## Technical product information

<b>Topic</b>	Convertible hood cannot close - Header trim flap eyelet broken
<b>Market area</b>	Bentley: worldwide (2WBE)
<b>Brand</b>	Bentley
<b>Transaction No.</b>	2060120/6
<b>Level</b>	EH
<b>Status</b>	Released for publishing
<b>Release date</b>	07-Nov-2022

### New Continental GTC

Figure 2

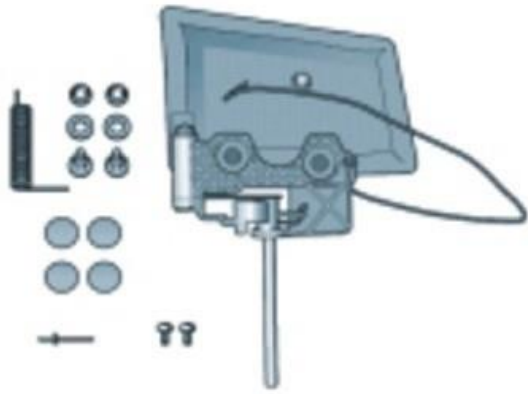
A kit of parts to replace the right and left hand trim flaps is now available (Figure 2)

NOTE: The trim flaps should be replaced in pairs
